Access Compliance Report Public Rights-of-Way (Curb Ramps)

Main Street: S_CHURCH_ST Cross Street: WALNUT_AVE Location: NE

ADA ID: RPAT211020101233 Ramp Type: Type 4 - Parallel Initial Pass/Fail: Pass Overall Compliance: No Severity Score: 5

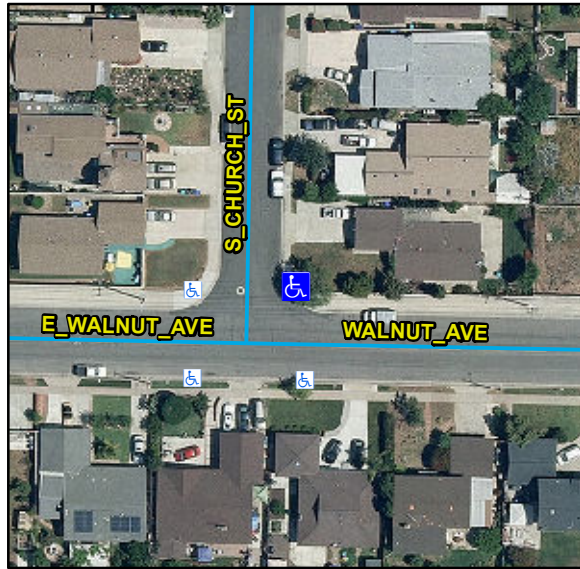
Crossing 1 Slope (%)	3.7		Crossing 2 Slope (%)	0.7
	Crossing 1 Cross Slope (%)	0.2		Crossing 2 Cross Slope (%)	5.3
No	Gutter Ponding	Yes	Yes	Curb Slope	3
Yes	Gutter Lip Height (in)	0		Road Run Slope (%)	6.8
No	Gutter Run Slope (%)	5.9		Road Cross Slope (%)	0
Yes	Gutter Cross Slope (%)	0.3	Yes	Perpendicular Joint Present	Yes
Yes	Overall Surface Condition	Acceptable			
	Cross Gutter Present?	No		Spandrel Present?	No
	Replace Cross Gutter?	N/A		Replace Spandrel?	N/A

Remove & Replace Gutter.
